Form 3160-3 (April 2004)		AUG :	<b>2 0</b> 200	J.Y OMB №.	PPROVED 1004-0137 urch 31, 2007	beri fast
UNITED STATES DEPARTMENT OF THE BUREAU OF LAND MAI	INTERIOR	Bureau of La Farmingto	nd Mana n Field (	5 Lease Serial No.		— (Land
APPLICATION FOR PERMIT TO				6. If Indian, Allotee of	or Tribe Name	noused country passed lates pour
la. Type of work: X DRILL REENT	TER			7 If Unit or CA Agree	ment, Name and No.	- C2
lb. Type of Well: Oil Well X Gas Well Other	X Sin	gle Zone Multip	ple Zone	8. Lease Name and W Coaly #

## EXHIBIT B OPERATIONS PLAN

Coaly #3

SUNDRY NOTICES AND REPORTS ON WELLS Do not use this form for proposals to drill or to re-enter  $\text{SpP}\ 16\ 2009$

Coaly #3

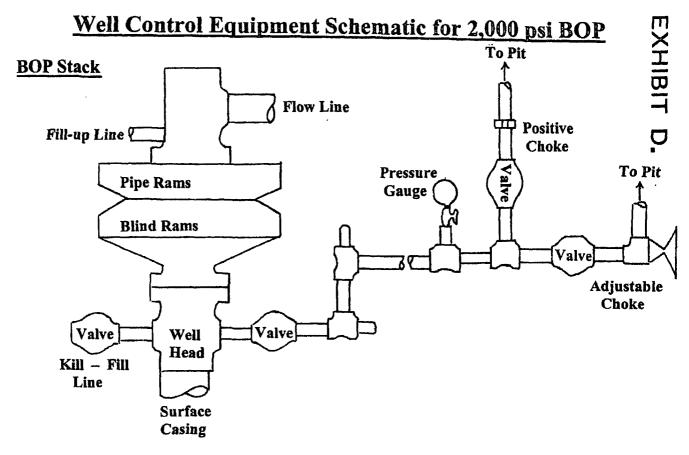
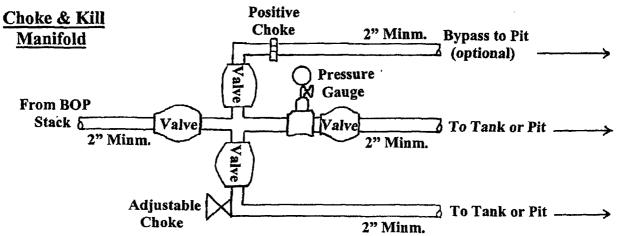
If the proposal is to deepen direction Attach the Bond under which the wo following completion of the involved testing has been completed. Final A determined that the site is ready for the Change the currently permitted configuration. The previous of the new configuration will alke the BOP stack can be done in Change the hole size for the proposed that the foregoing is the proposed that the proposed that the foregoing is the proposed that the proposed	ally or recomplete horizontally, job will be performed or provide d operations. If the operation restandonment Notices shall be file final inspection.)  If a blow out preventer configuration used a 7-1/16 power for a test plug to be set a conventional manner. If the production casing to 7-7/8" be adjusted to compensate urface. If the strue and correct the structure and structure the structure and structure the structure and structure the structure and structure the structure the structure and structure the structure the structure the structure and structure the structure	give subsurface to the Bond No on fulls in a multiple old only after all record on the casing has been also for the increase of the	cations and meas alle with BLM/BL. completion or recupirements, including all ram BOP. ead such that a permitted hosed hole size to the si	ured and true ve A. Required sub ompletion in a n ding reclamation ram testing of le size was o allow for	rtical depths of all pertusequent reports shall be lew interval, a Form 316 to have been completed,  RCUD JU  OIL CON  DIS	nent markers and zones filed within 30 days 60-4 shall be filed once and the operator has  1 12 10

Working Pressure for all equipment is 2,000 psi or greater
